H083 MAINTENANCE NOTE NO. 2
(For Electronics Technicians)

2. Transmitter Box Door Seal Repair

SUBJECT: Transmittal Memorandum for Engineering Handbook No. 8, Issuance 86-9

ERRATA SHEET NO. 1 TO MAINTENANCE NOTE 2

FIGURE 1

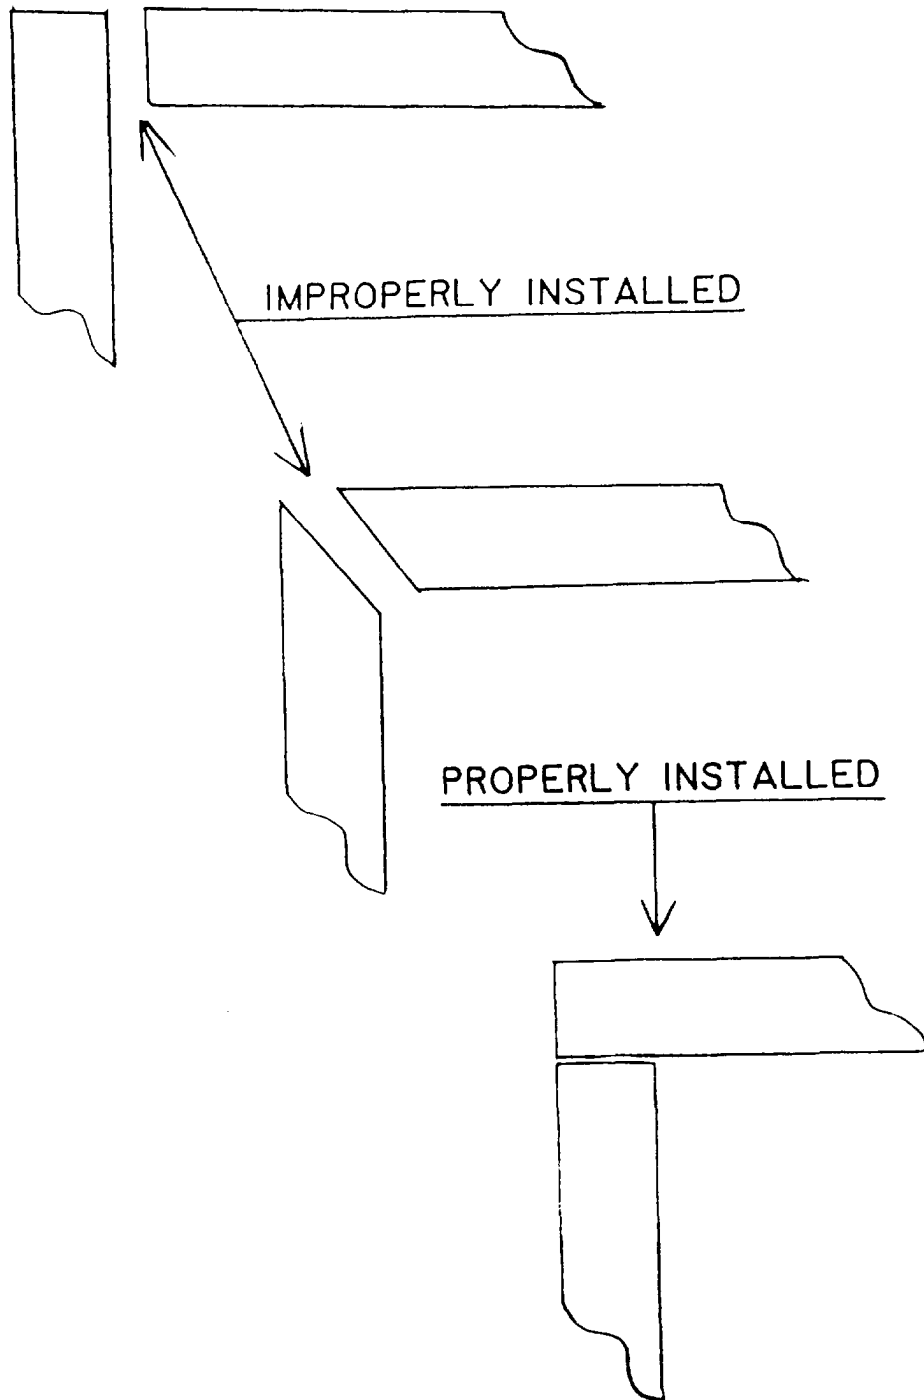
This maintenance note contains instructions to correct the problem of water leaking into the H083 transmitter box by application of an RTV sealing compound, for those transmitter door seals that were improperly installed.

1. Open the transmitter door on the H083.
2. Apply RTV sealing compound liberally filling the gap between adjacent door seals with an excess amount of compound to ensure a good seal.
3. After using wax paper or a thin layer of silicone grease opposite the door seal to act as a mold release, close and secure the transmitter door. Leave in place until fully cured (about 24 hours).
4. After fully cured, remove wax paper or wipe off silicone grease.

FIGURE 1

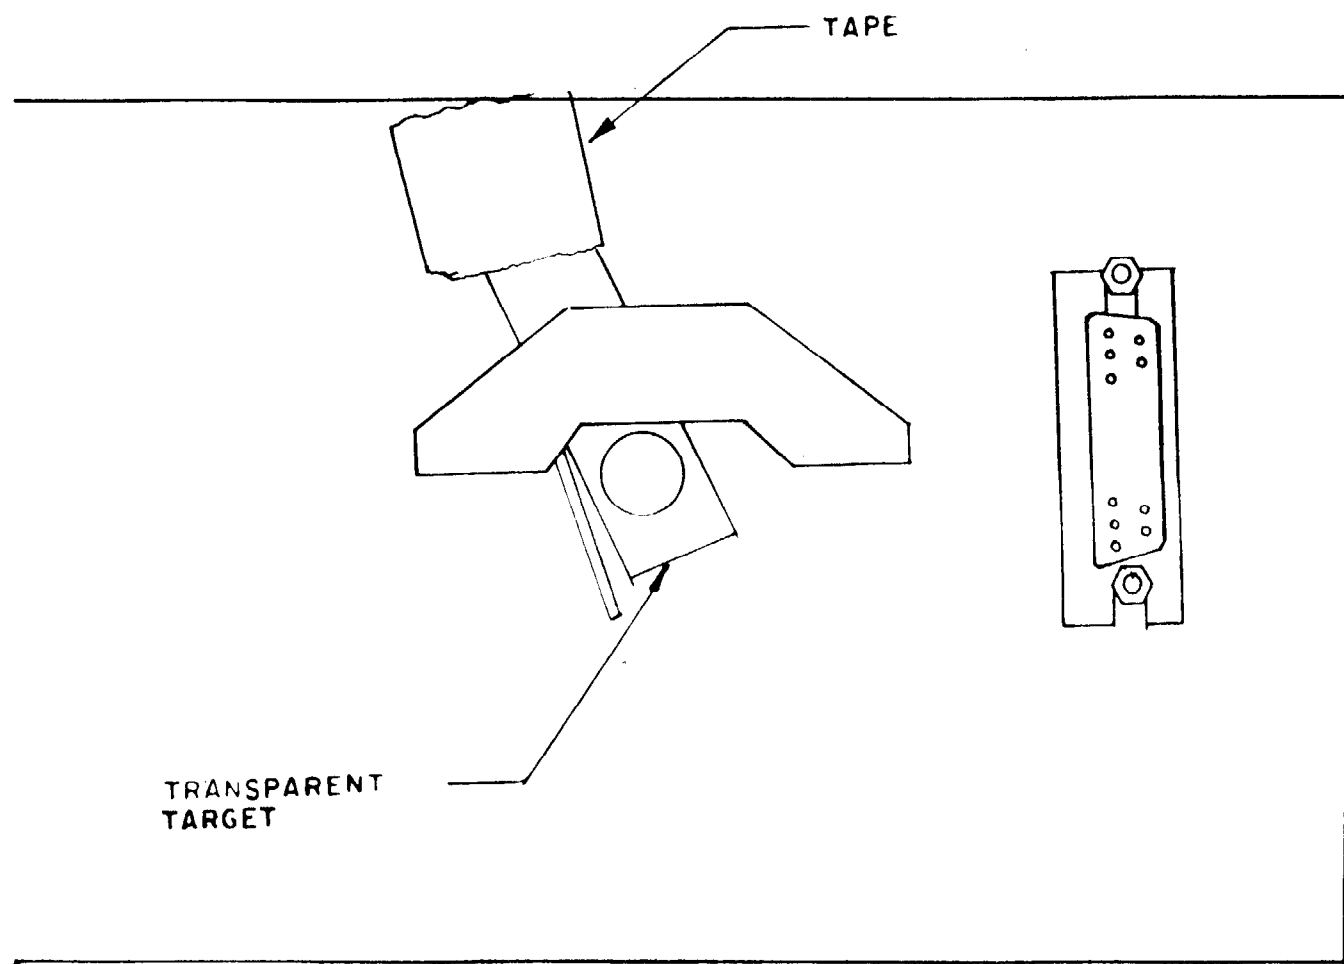
7. Position the transparent target over the mirror, and tape down the opposite end (see figure 1).
8. Slide the infrared strip between the mirror and target (see figure 2). You may have to trim about 3/16 inch from either side of the clear plastic material next to the 3/4-inch square sensitive area.

FIGURE 1

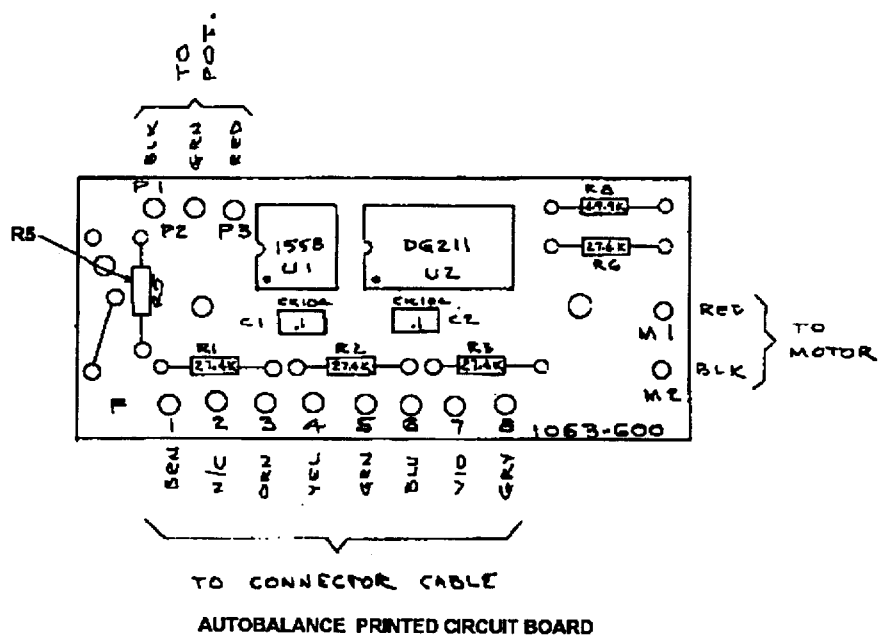
The modules differ in the threshold resistor (R5) that determines the sensitivity of the autobalance function to dirt on the mirror. Both versions, described below, are now stocked.

A. On the next trip to each site, inspect the R5 resistor for its value. Reference the autobalance printed circuit Figure 1 for location of R5 resistor.

- B. The resistor is marked with the resistance value. If marked with 249xx, the value is a 249K ohm resistor and is correct. If the resistor is positioned so that the resistance value is not visible, use a multi meter to decide the value. A resistance reading near 250K ohms is correct. A reading closer to 200K ohms is incorrect.
- C. If it is determined that the correct R5 resistor is installed, reinstall the autobalance.
- D. If it is determined that the incorrect R5 resistor is installed, return the autobalance module to NLSC and replace with the correct module.
- E. Inspect the spare's kit and return any autobalance modules found to NLSC. Most kits did not include the autobalance module.
- F. Order from NLSC per information in section 1C above. Documentation was changed to reflect the new logistics information.

A. Two different autobalance modules will be stocked: one for the ASOS hygrothermometers (R5 = 200K ohms) and one for the remaining station HO83 hygrothermometers (R5 = 249K ohms).
